Planning Referral

To: John Theodosakis
From: Julian Wearne
Date: 17/04/2018
Subject: Strategic Transport Comments
Application No: PLN17/0920
Description: Amendment to the Development Plan to develop the central and southern portion of the Channel Nine Site for an aged care facility / retirement village and a section of the site for affordable housing, including town houses.
Site Address 171 Stawell Street, Richmond

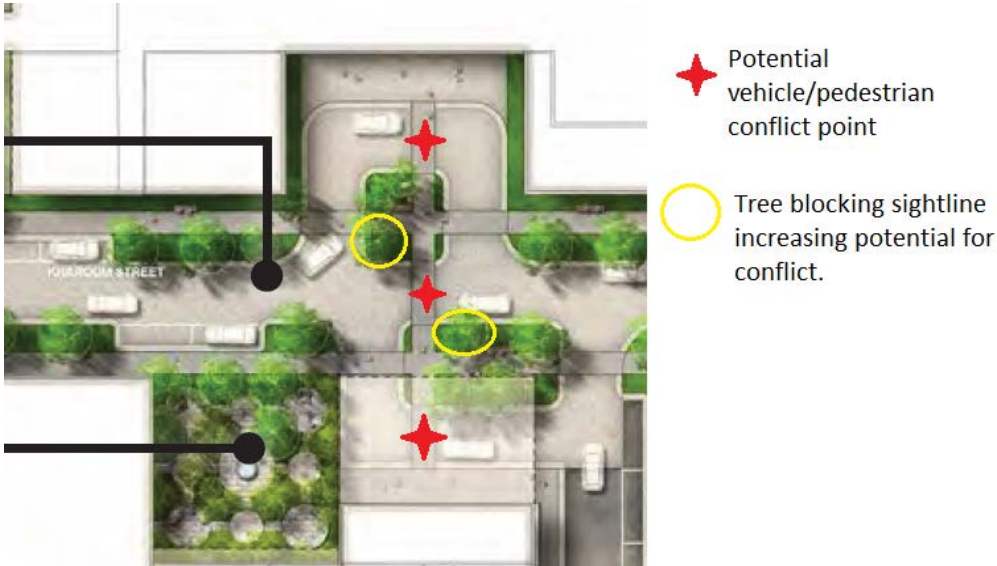
Reduced conflict points along pedestrian crossings and improved sightlines

The major north-south pedestrian crossing shown between the aged care facility and the apartments to the north currently crosses 3 potential vehicle conflict points (Figure 1). This is considered unacceptable and unnecessary. The path should be relocated east or west as to not cross the horse-shoe driveways. Further trees are currently shown on the pedestrian "refuge islands" which should be deleted, as these are likely to block sightlines and increase likelihood of conflict.

- 1) Reference to the formal shared zone proposed at Khartoum Street removed.
- 2) The main north-south pedestrian crossing across Khartoum Street relocated or redesigned to reduce the number of potential conflict points.
- 3) Tree and vegetation planting relocated or redesigned to ensure safe sight-lines are possible at pedestrian crossings and potential vehicle / pedestrian conflict points.
- 4) The design of townhouses proposed between Stawell Street and Kennedy Avenue altered to reduce potential conflict between vehicles and pedestrians.
- 5) Bicycle parking rates outlined at the rates described previously.
